SUBJECT: **Safety Recall 07S48: Supplement #1**
Certain 2003 through 2005 Model Year Crown Victoria Police Interceptor (CVPI)
Vehicles - 16" Steel Wheel Replacement

New! REASON FOR SUPPLEMENT #1

*The purpose of this supplement is to provide revised **Technical information to assist you in identifying affected steel wheels.***

FIGURE 1

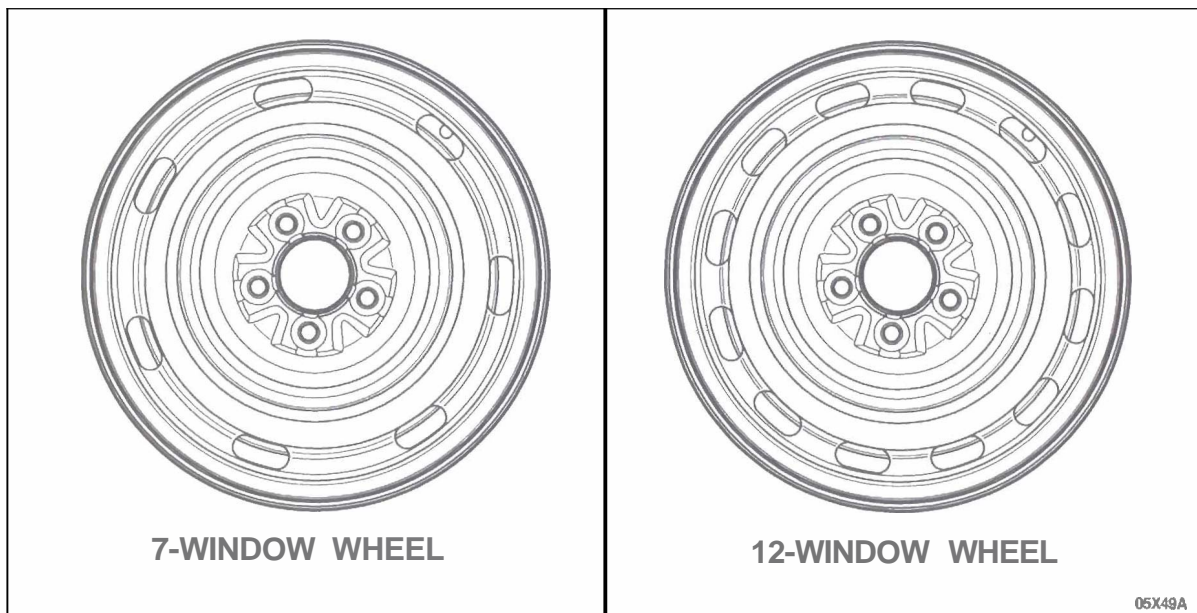
All replacement wheels will be of the 12-window configuration. See Figure 1.

FIGURE 2

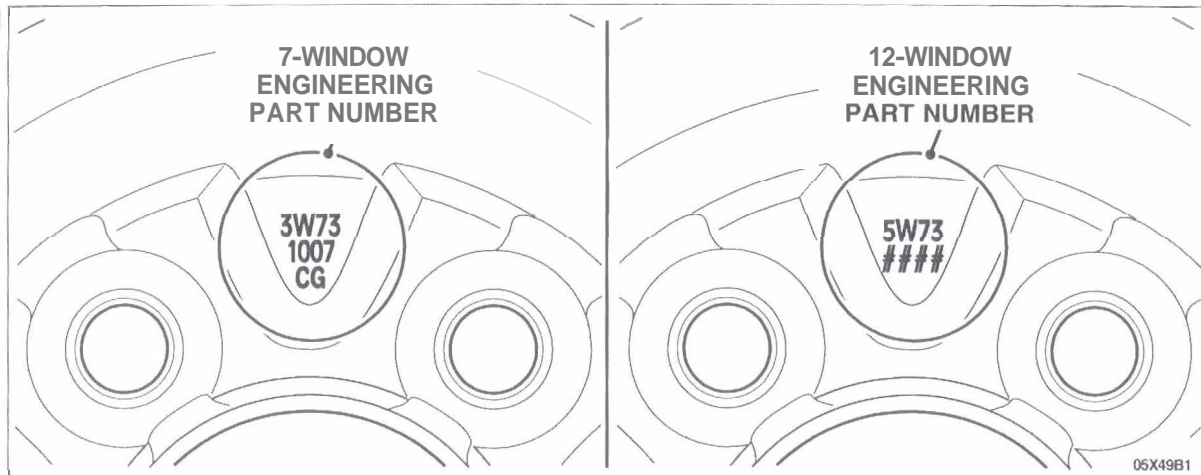
Inspect the engineering part number on all wheels including the spare. See Figure 2.

Is the part number stamped on ALL the 7-window wheels 3W73-1007-CG?	YES	Vehicle not eligible for new wheels. Advise the customer the vehicle is already equipped with the latest level wheels.
	NO	All wheels on vehicle are eligible for replacement using new 12-window wheels – Order SPN - 5W7Z-1007-AA. (a)

Is the part number prefix stamped on ALL the 12-window wheels 5W73?	YES	Vehicle not eligible for new wheels. Advise the customer the vehicle is already equipped with the latest level wheels.
	NO	Only wheels NOT stamped with 5W73 part number prefix are eligible for replacement using new 12-window wheels – Order SPN - 5W7Z-1007-AA. (a)

FIGURE 3

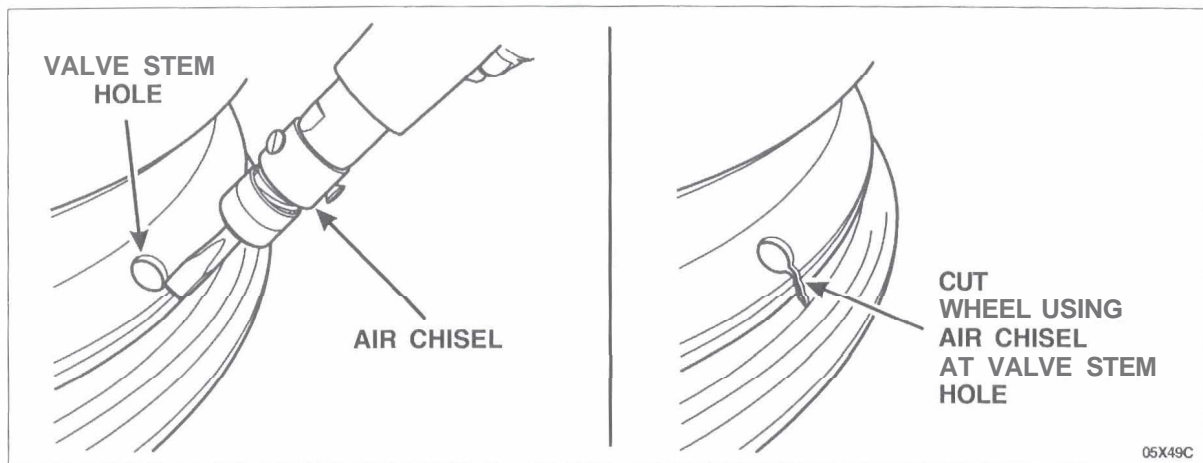
1. **With** the wheel facing down, use an air chisel with a sharp bit to cut a gouge no less than 12 mm (1/2 inch) long in the wheel from the valve stem hole down toward the bead area. The gouge must be large enough and the wheel deformed enough to make sure it cannot be easily repaired. See Figure 3.
2. Retain the wheel for possible warranty parts return. See your service manager or parts manager for further instruction.
